# Access Compliance Report

## Public Rights-of-Way

### (Curb Ramps)

Intersection ID: 31910	Main Street: PALOMAR_MOUNTAIN_DR	Cross Street: STOWE_DERBY_DR	Location: SE
ADA ID: AA1ED82D3B35	Ramp Type: PerpDiag	Initial Pass/Fail: Fail	Overall Compliance: No
Severity Score: 46.25			
Codes/Mitigation Info/Possible Solution		Field Measurements/Component Compliance

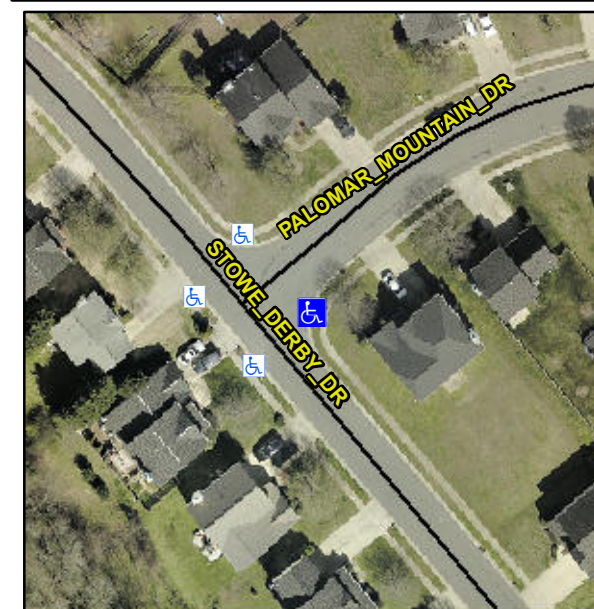
**R304.5.1, R304.2.2, R304.5.3**

Compliance	Description	Data	Compliance	Description	Data
N/A	Ramp Length (in)	47.5	No	Ramp Slope (%)	10.2
No	Ramp Width (in)	46.5	No	Ramp XSlope (%)	8.5
N/A	Flare Type LT	N/A	N/A	Flare Type RT	N/A
N/A	Flare Slope LT (%)	N/A	N/A	Flare Slope RT (%)	N/A
N/A	Flare Traversable LT?	N/A	N/A	Flare Traversable RT?	N/A
N/A	Landing Length (in)	N/A	N/A	DWS Provided?	N/A
N/A	Landing Width (in)	N/A	N/A	DWS Contrast?	N/A
N/A	Landing Slope (%)	N/A	N/A	DWS Length (in)	N/A
N/A	Landing X Slope (%)	N/A	N/A	DWS Full Width?	N/A
N/A	Landing Curb? (Y/N)	N/A	N/A	DWS Offset (in)	N/A
N/A	Shared Landing?	N/A			
N/A	Gutter Ponding?	N/A	N/A	Gutter Slope (%)	N/A
N/A	Gutter Lip Ht (in)	N/A	N/A	Gutter X Slope (%)	N/A
N/A	Painted X Walk1?	No	N/A	Painted X Walk2?	No
	X Walk 1 Direction	To NW		X Walk 2 Direction	To SW
N/A	X Walk 1 Width (in)	N/A	N/A	X Walk 2 Width (in)	N/A
	X Walk 1 Slope (%)	3.4		X Walk 2 Slope (%)	2.8
	X Walk 1 X Slope (%)	6.7		X Walk 2 X Slope (%)	3.7

N/A	Ramp inside XWalk1?	N/A	N/A	Ramp inside XWalk2?	N/A
	Road Slope (%)	7.6	N/A	Clear Space?	N/A
	Road X Slope (%)	2.3	N/A	Clear Space to XWalk (in)	N/A
N/A	Any Obstructions?	N/A	N/A	Storm Grate/Utility Hazard?	N/A
	Obstruction Type			Storm Grate/Utility Type	
		N/A			N/A
			Yes	Surface Condition? (G/P)	Good

**Remove & Replace Curb Ramp With Two New Directional Ramps or Equivalent.**
